# LAYTON TREE CONSULTING, LLC

## TREES & CONSTRUCTION MEMO

To: Paul Bosveld  
From: Bob Layton  
CC: Heather Crain, Matt Wittman  
Date: March 31, 2022  
Re: Tree Protection at 38XX W Mercer Way

EAST PROPERTY LINE

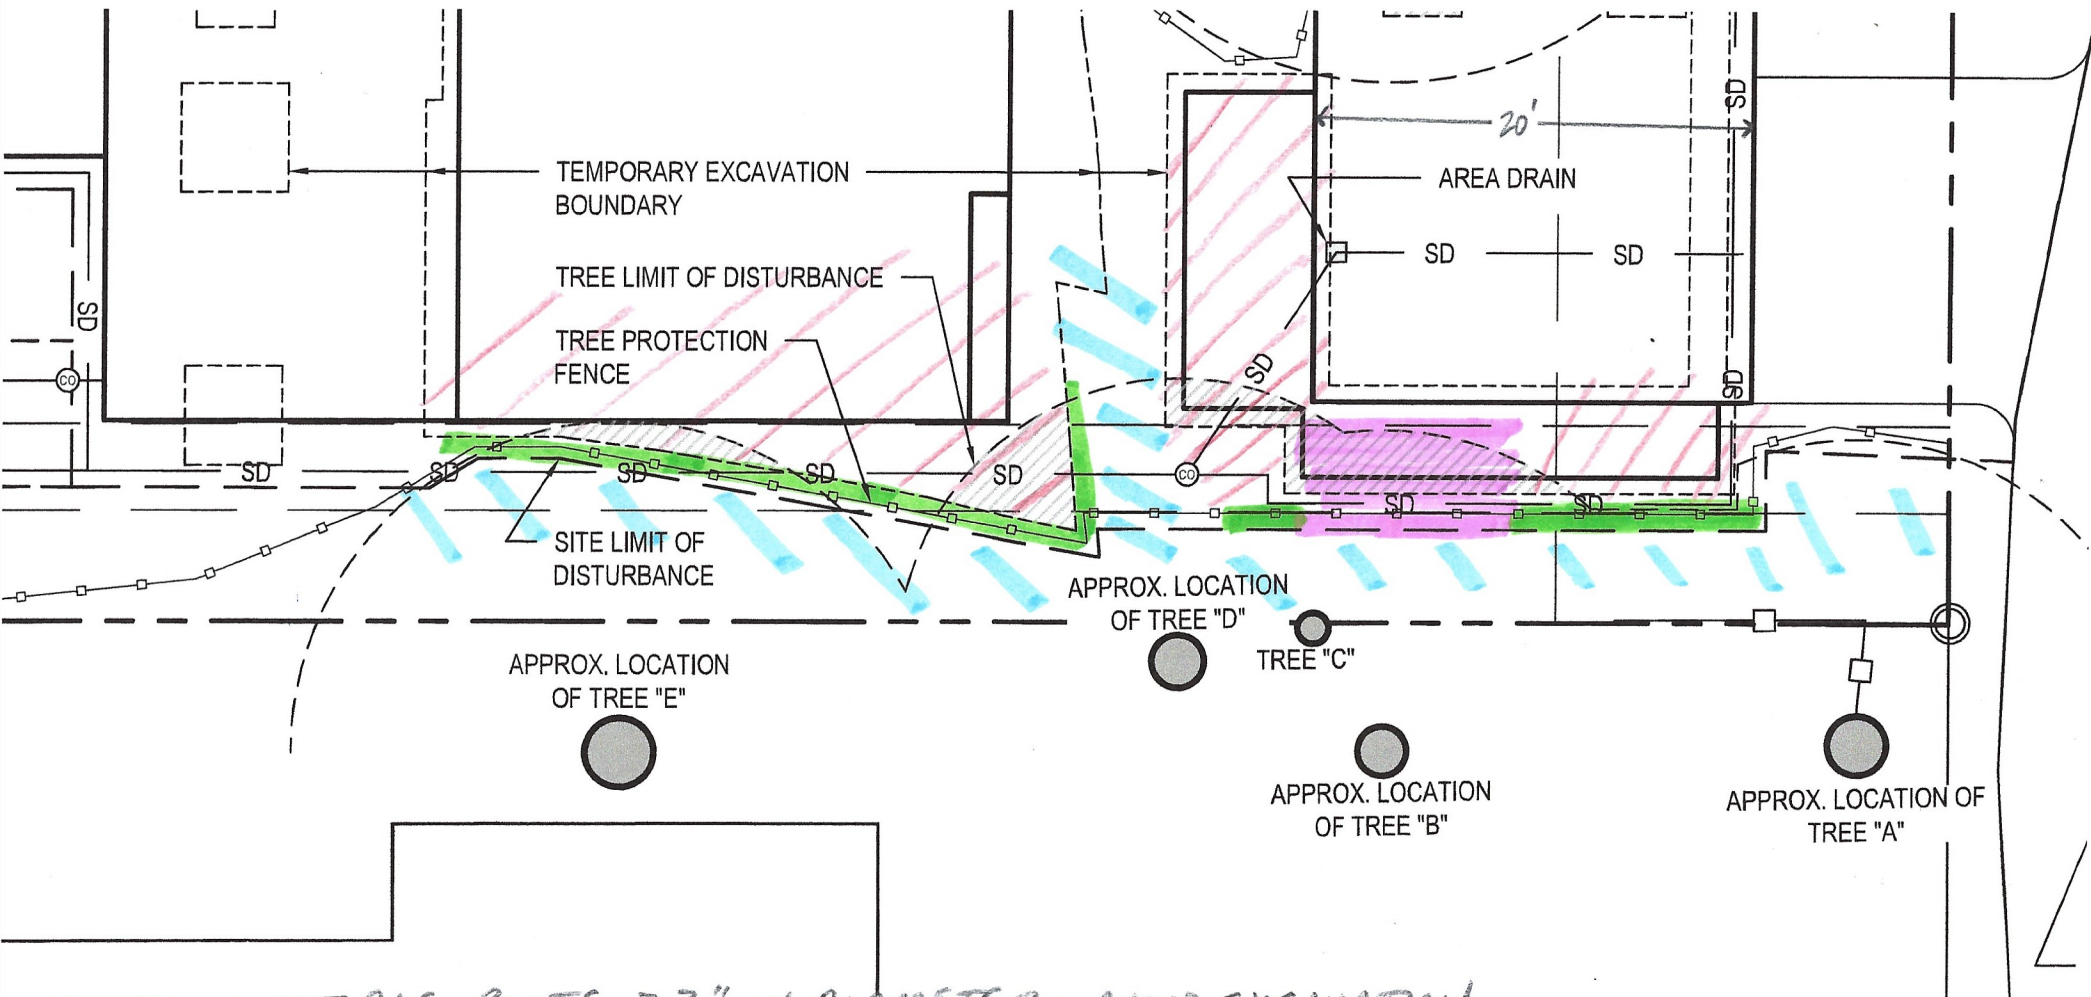
Another trench was air-excavated adjacent to the east property line at the proposed excavation extents. A cluster of +/- 5 structural roots exist directly west of Tree B. See the attached map. These will need to be protected. A continuous concrete footing at this location is not possible.

Footings can be poured at the northeast and southeast corner, and mid-span of the garage to support the floating garage floor. Excavation for a below grade storage compartment west of Trees B and C is not recommended. A smaller storage compartment at the northeast corner of the garage could be excavated out without having any significant impacts on neighboring trees.

- MULTIPLE ROOTS > 2" IN DIAMETER - AVOID EXCAVATION
- NO SIGNIFICANT ROOTS PRESENT - OKAY TO EXCAVATE FOR CONCRETE FOOTINGS
- PLACE +/- 6-INCH LAYER OF WOODCHIP MULCH OR HOG FUEL
- AREAS TO BE EXCAVATED
